STEVAL-CCA058V1 board limitations

Board identification

This errata sheet applies to some STEVAL-CCA058V1 kits that have the operational amplifier board shown in the figure below.

Figure 1. STEVAL-CCA058V1 training kit

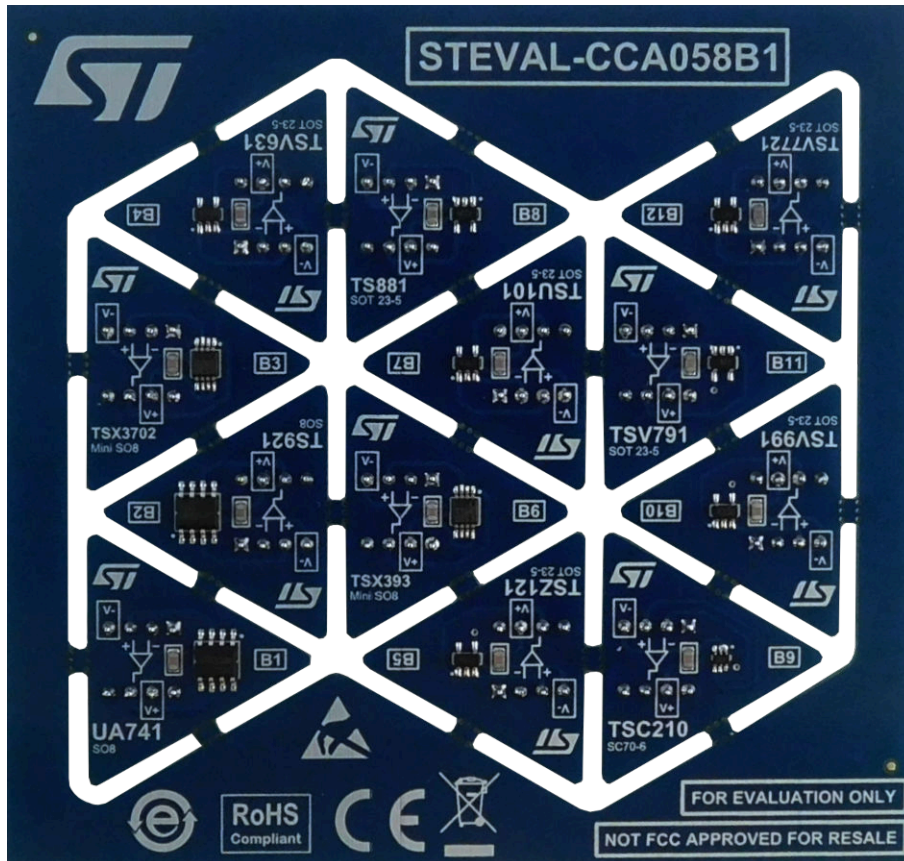
The only board affected by the limitation is the STEVAL-CCA058B1 marked as shown in the following figure.

TS881 and TSV7721 adapters present on the STEVAL-CCA058B1 have an incorrect pinout connection and are not compatible with the standard DIP single pinout.

They are therefore not usable with the STEVAL-CCA058A1. Other devices present in the kit may be used normally.
